From: Rael, Rudy E.
Sent: Monday, December 05, 2016 10:02 AM
To: 'Fred Arfman (freda@iacivil.com)'; 'bryanb@IACIVIL.COM'
Cc: Biazar, Shahab; Carrillo, Abiel X.
Subject: Eastside Renovation of Kennel D Canine Facilities

Project Title: Eastside Renovation of Kennel D Canine Facilities Building Permit #: _____ City Drainage #: K20D063

Based upon the information provided in your resubmittal received 5/9/16, the above referenced Grading and Drainage Report and plan cannot be approved for Building Permit until the following comments are addressed:

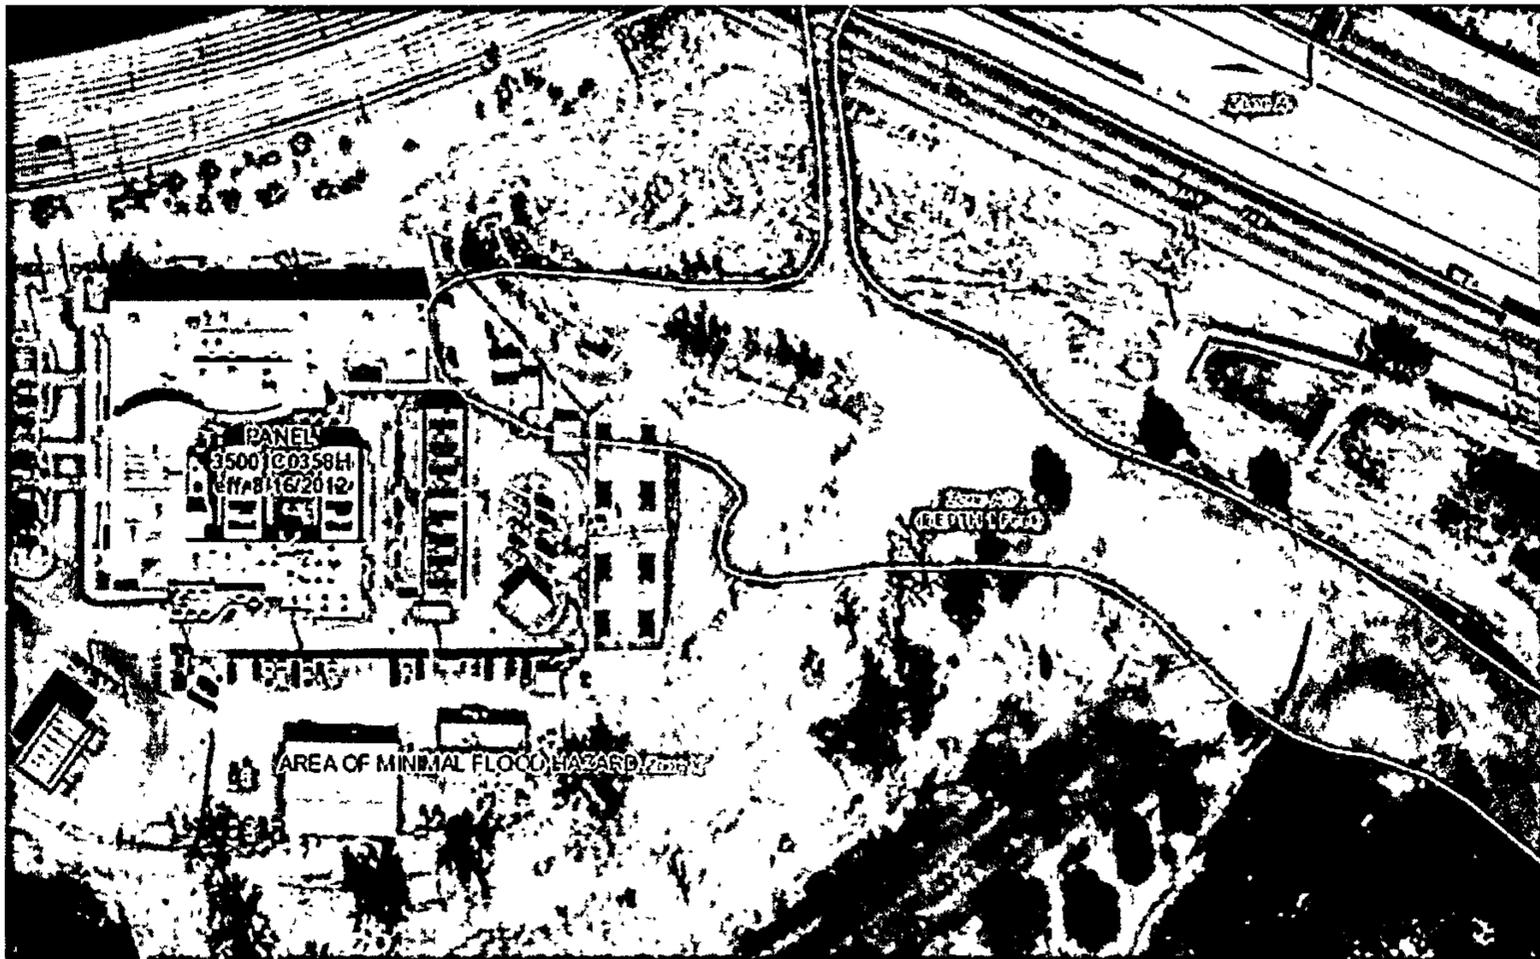
1. According to the latest FIRM, the smaller building just north of the parking area will be in Zone AO (1' Depth, see below). The finished floor will need to be set *at least* 1' above the highest adjacent grade to the building.

2. Overlay (approximately) the limits of the SFHA on the plan.
3. Processing a Floodplain Permit will be made a condition of Building Permit approval.
4. Stamp and date the revised plan.
